**PVC CLAYPOOL BUILDING SCOPE DESCRIPTION**

UPDATE 3/20/19

The following list of scope items is to be used together with the attached DSA approved set of plans.

**CLAYPOOL BUILDING RECONSTRUCTION**  
PALO VERDE COLLEGE, NEEDLES CENTER  
PALO VERDE COMMUNITY COLLEGE DISTRICT  
725 WEST BROADWAY STREET, NEEDLES, CALIFORNIA 92363

DATE	07-06-07	CHECKED	JVT
JOB NO.	2007-SH95-00	DRAWN	KK
SHEET NO.		DATE	
A1.1		APR 17 2011	
SHEET		OF	
SHEET		OF

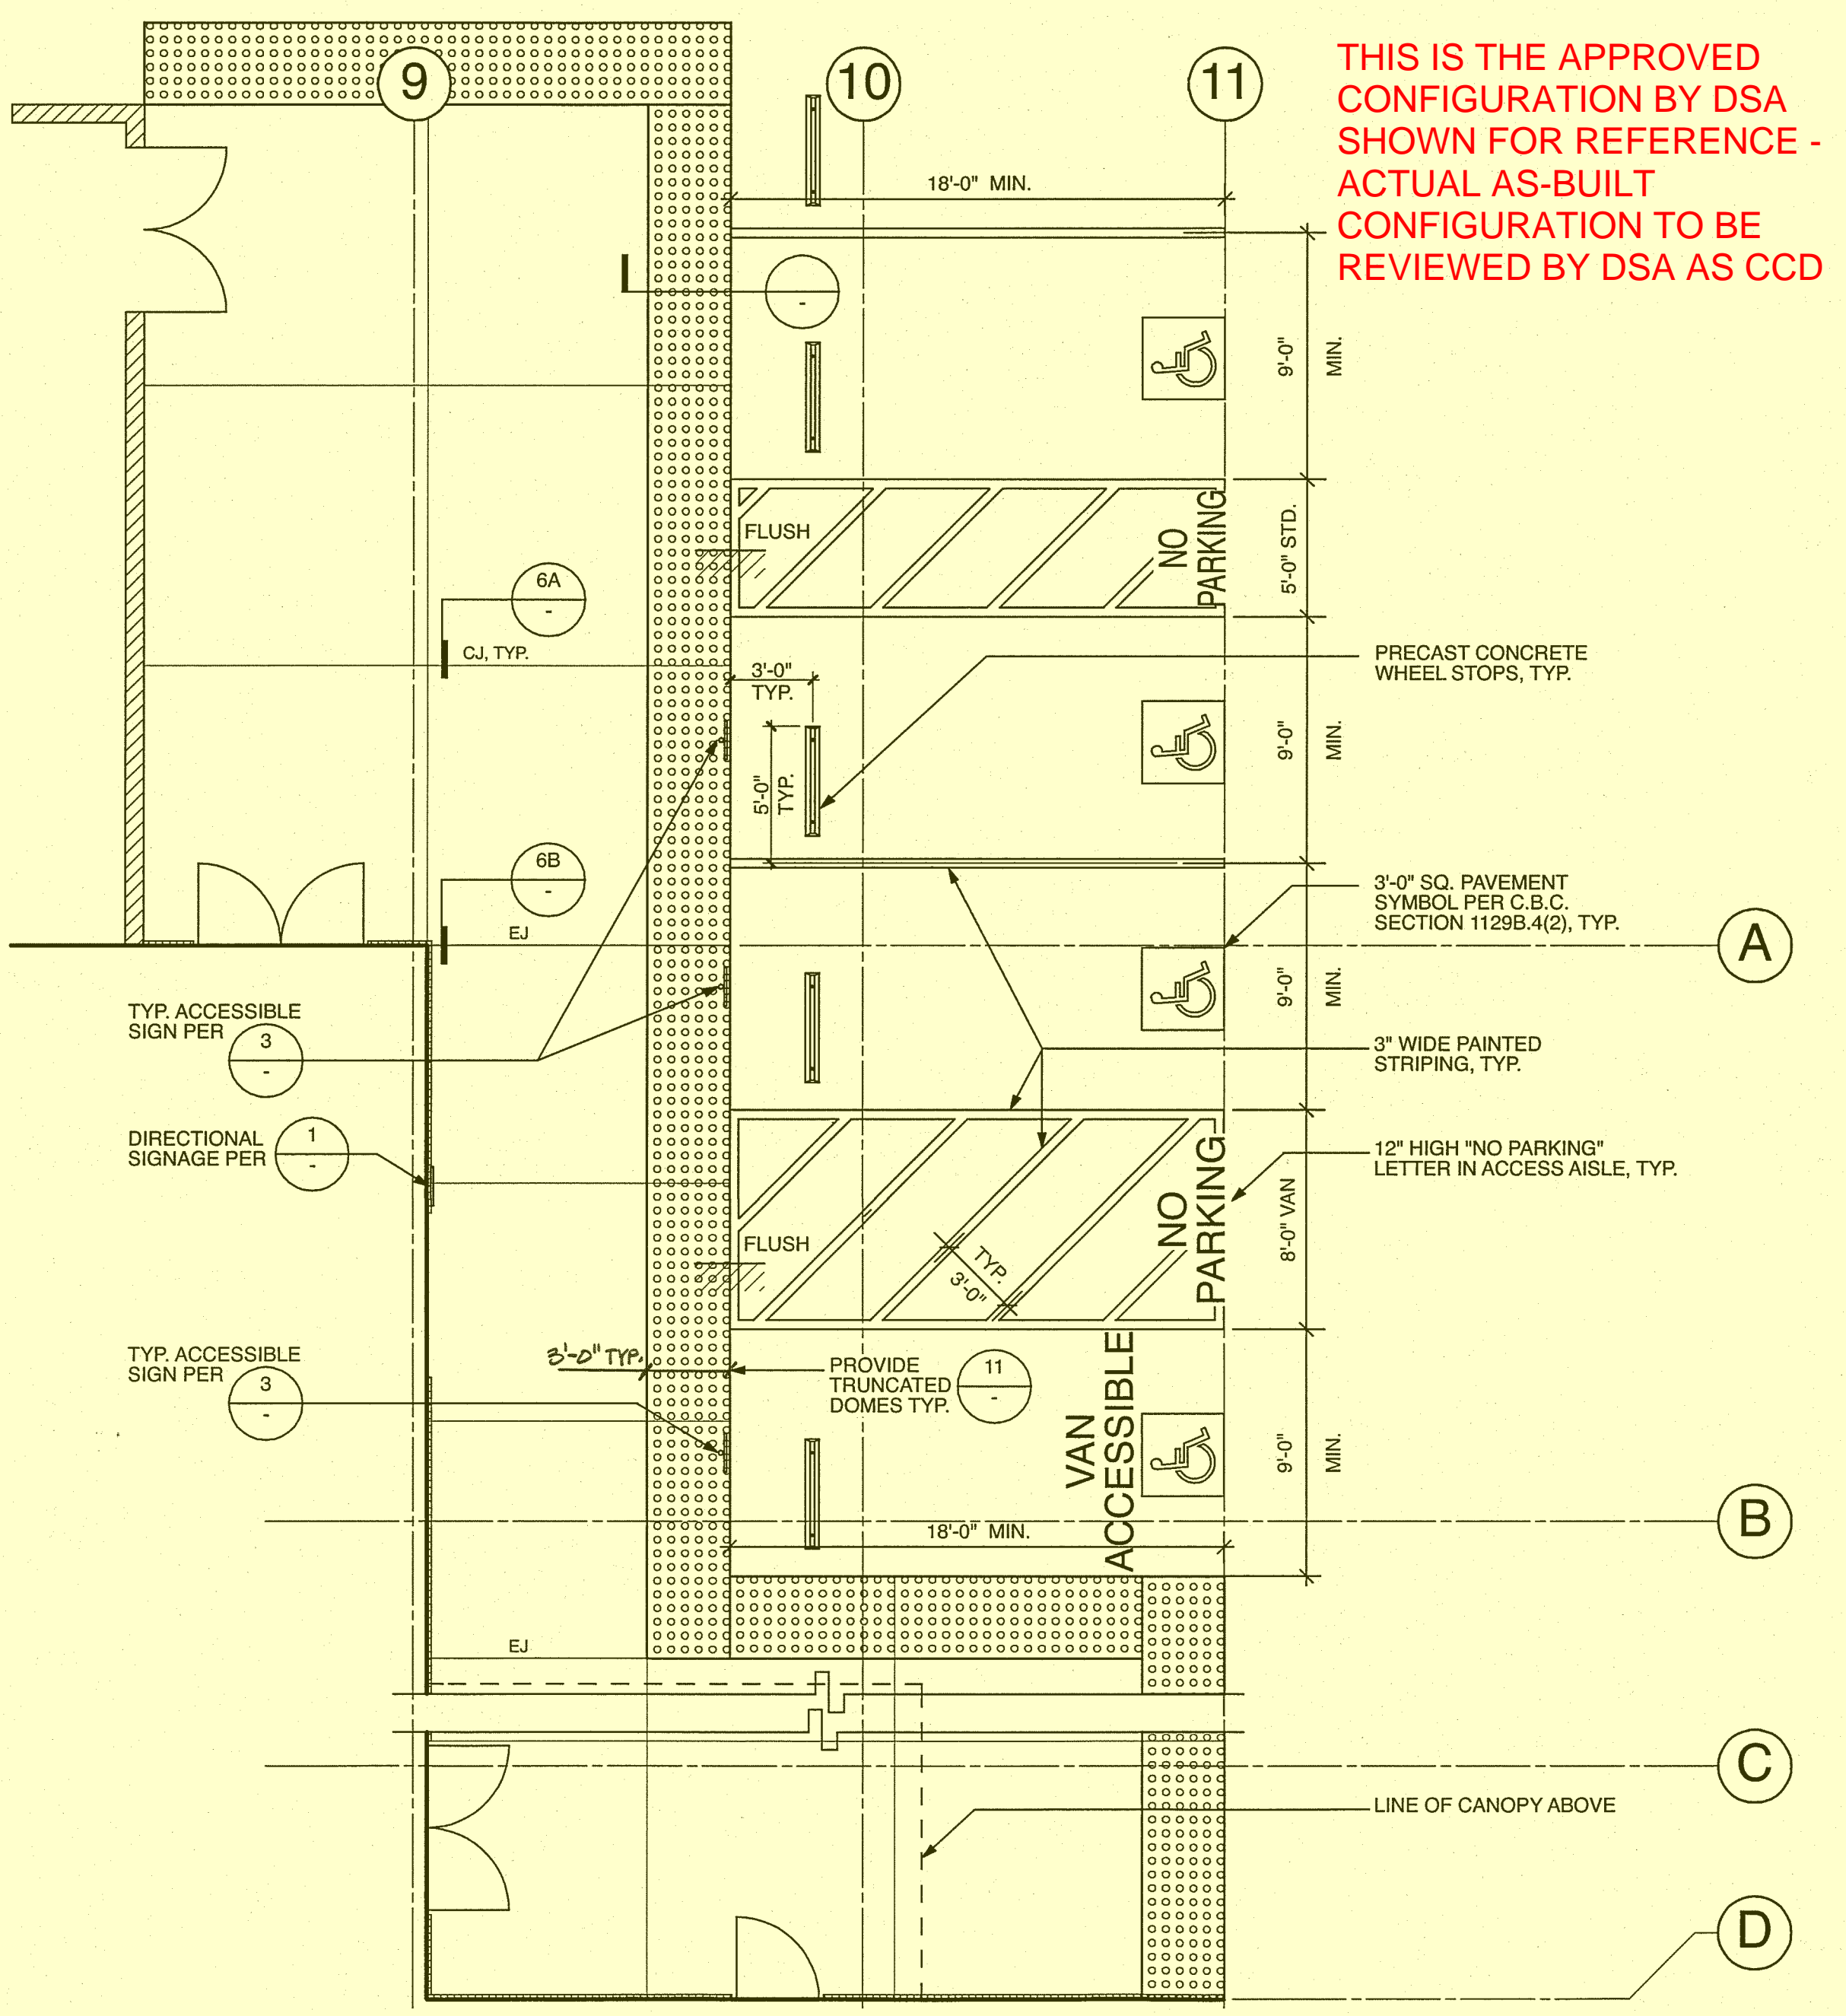
ITEM #	DSA SET SHEET #	LOCATION ON SHEET	ITEM DESCRIPTION	DESCRIPTION OF CORRECTIVE WORK REQUIRED	REMARKS	DESTRUCTIVE INVESTIGATION FIELD FINDINGS
<b>ARCHITECTURAL</b>						
A-001	A1.1	Site Plan - East of building	DSA set shows addition of concrete ADA pathway from public right of way (Main Broadway) across DG area to connect with path of travel adjacent to rear parking area	Install new concrete path as shown on DSA approved set		N/A
A-003	A1.1	East of rear entrance	Existing condition observed: Concrete steps lead to traffic aisle with no tactile warning (domes)	Install truncated domes as shown on approved set		N/A
A-004	A2.2	Grids 2-B	DSA set shows reconfiguration of entry stairs and addition of wheelchair lift	Reconfigure entry stair and install wheelchair lift as shown on approved set		N/A
A-005	A2.2	Grids 2-B, 4-C, 11/A7.1	DSA set calls for fully rated (1 hour) egress stair from basement level to exterior exit to Broadway. Reference also 11/A7.1	Provide 1-hour rated enclosure per approved plans		N/A

THIS IS THE APPROVED CONFIGURATION BY DSA SHOWN FOR REFERENCE - ACTUAL AS-BUILT CONFIGURATION TO BE REVIEWED BY DSA AS CCD

SHEET NO. **A2.2**

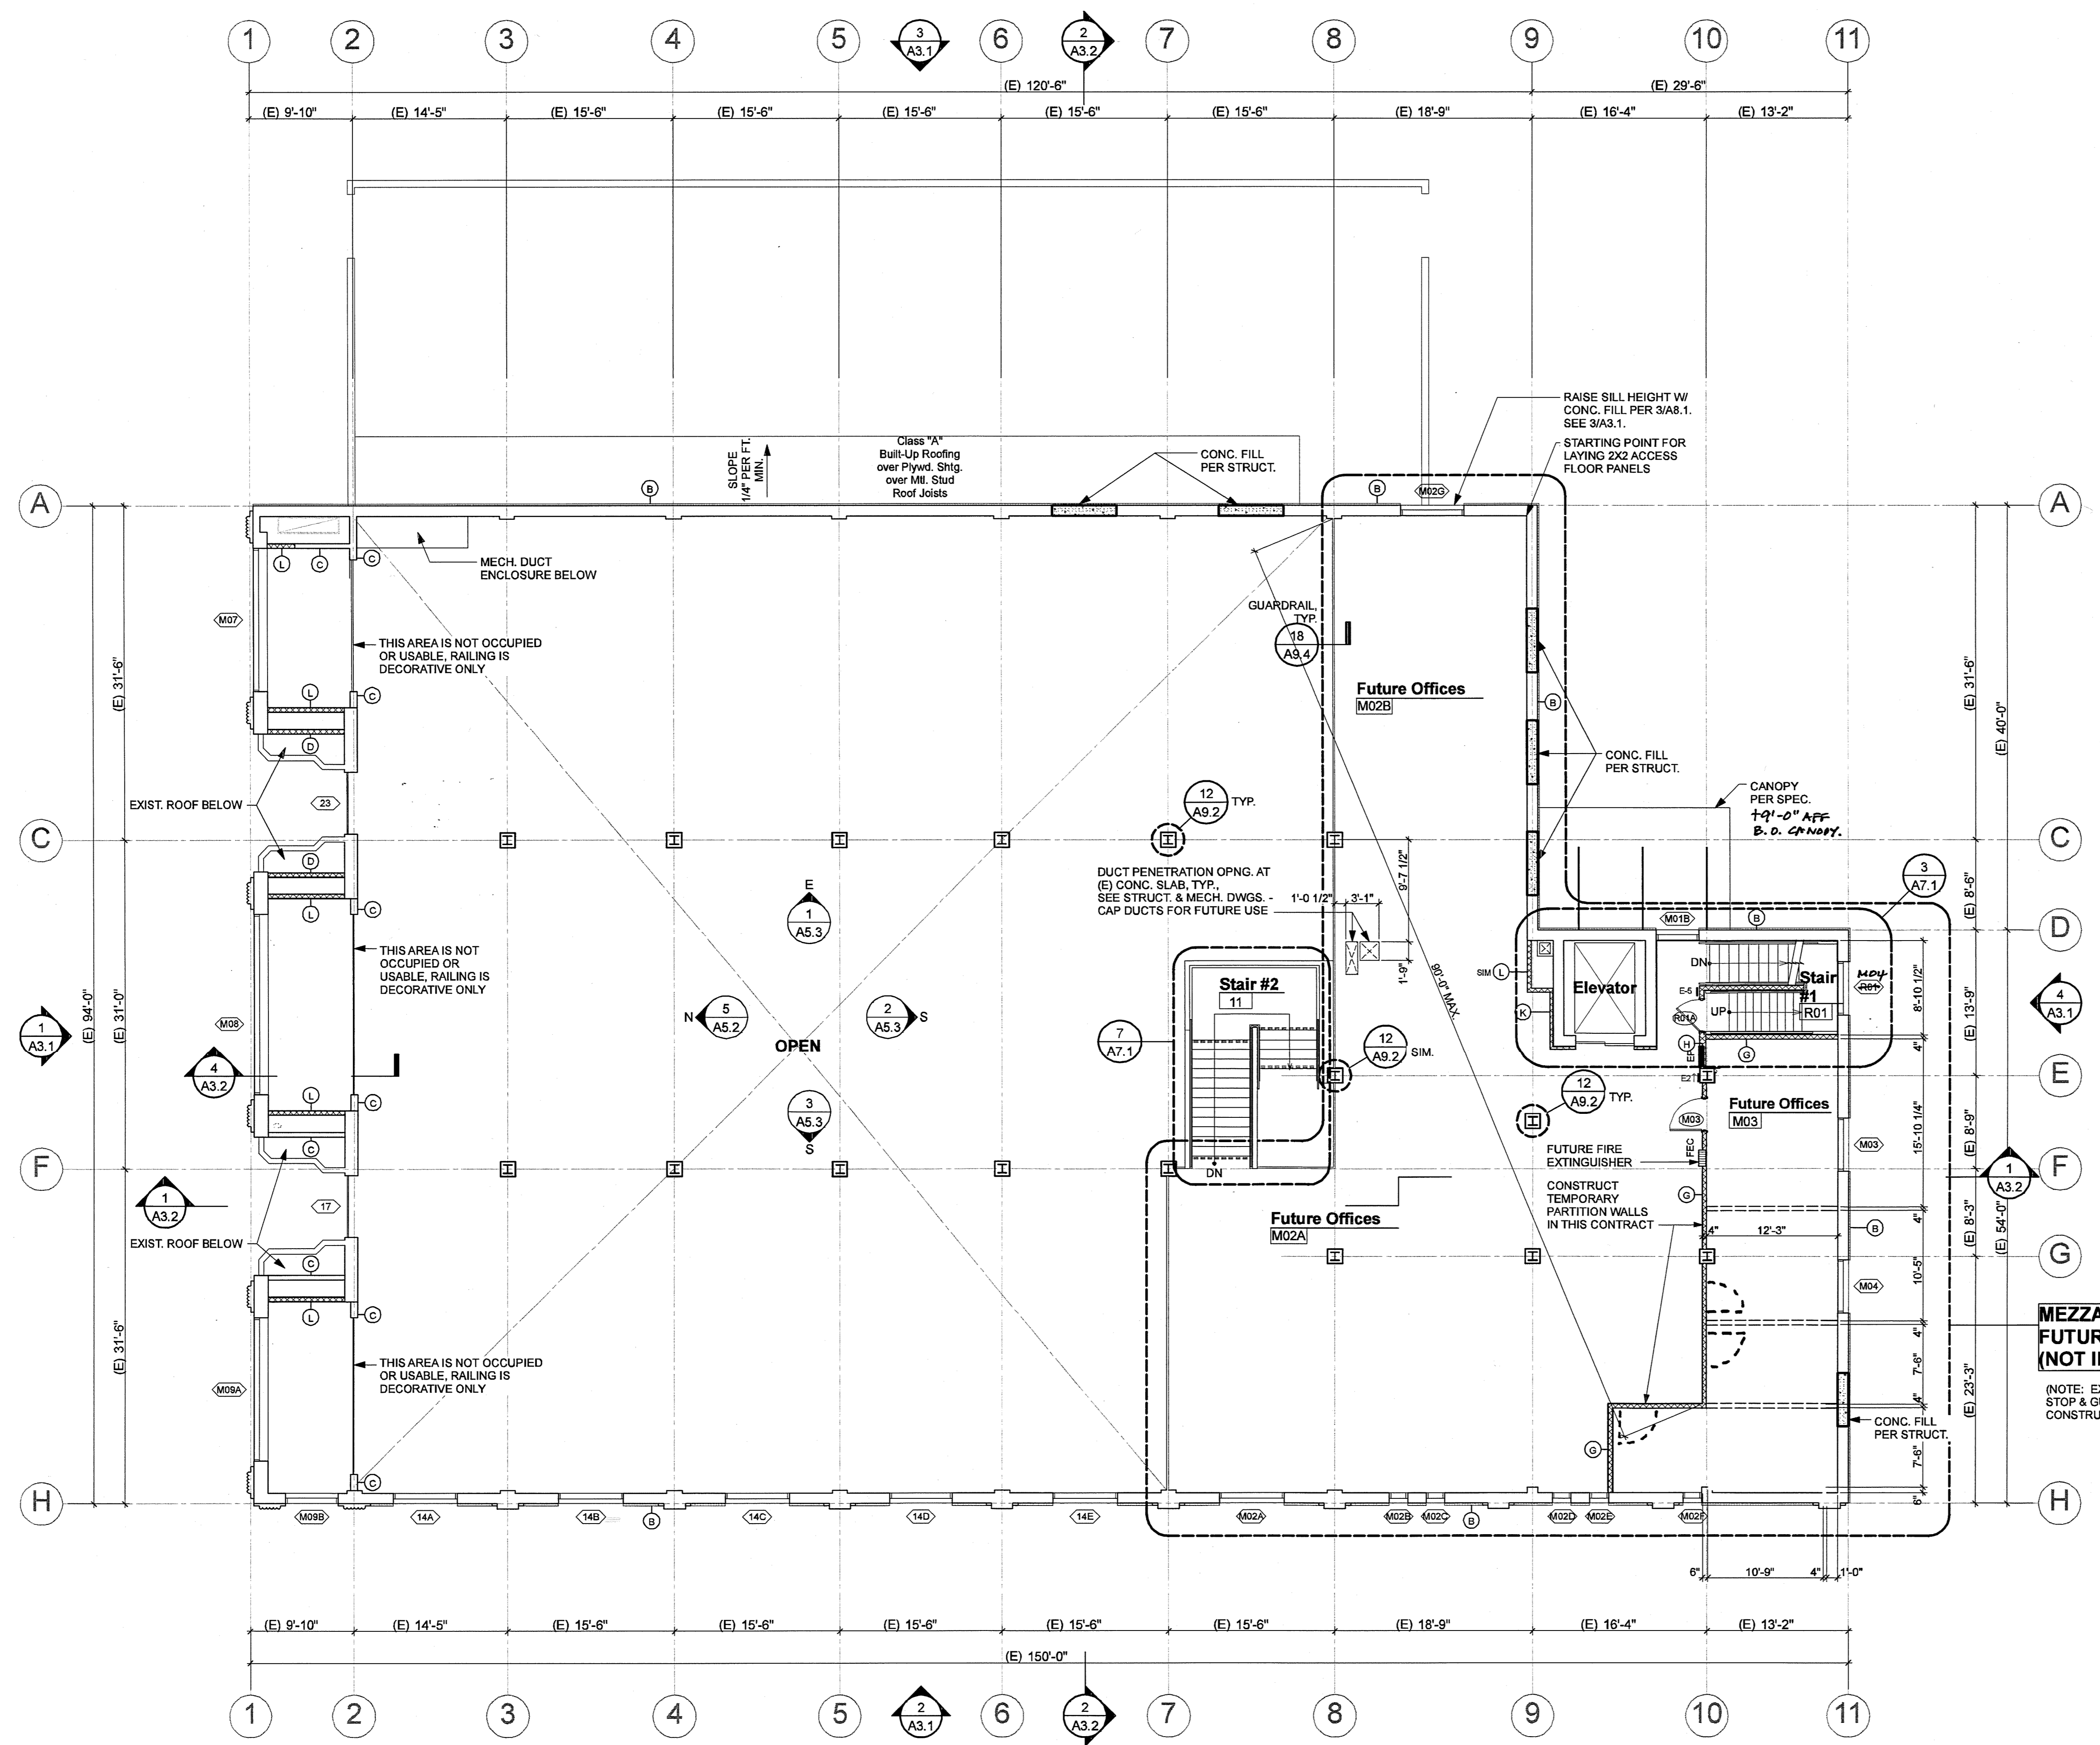
A-006	A2.2	Grids 7-F	Storage Room 11B under Stair #2 is not of 1 hour construction as noted on DSA set and required by code	Install Type X gyp board to underside of steel stairs to create a 1-hour envelope at Storage Room. Seal all gaps and penetrations as required.		Existing gyp board is fire rated, but stops at underside of stringer and does not cover underside of stairs.
A-007	A2.2	Grids 9-D, 10-E	DSA set shows addition of wall running north-south to enclose Stair #1 and the addition of a door leading to exterior exit to serve as egress from mezzanine level	Install new wall and door per approved plans. Reference 2/A7.1		N/A
A-009	A5.1	Elevation #3, South	DSA set shows added detail callouts to 14, 15 & 16 on A7.4.	<b>ALLOWANCE #1: CONTRACTOR TO OPEN BOTTOM PORTION OF ALL WALLS AT THE BASEMENT LEVEL AND ADD 3/16" DIA. HILIT KWIK CON 2 @ 32" O.C. AS REQUIRED BY DETAIL 10/A7.4</b>		Hiliti connections were found at the first floor. However, Hiliti connections were not found at the basement level. Only SMS is connecting track to floor. Connection not adequate
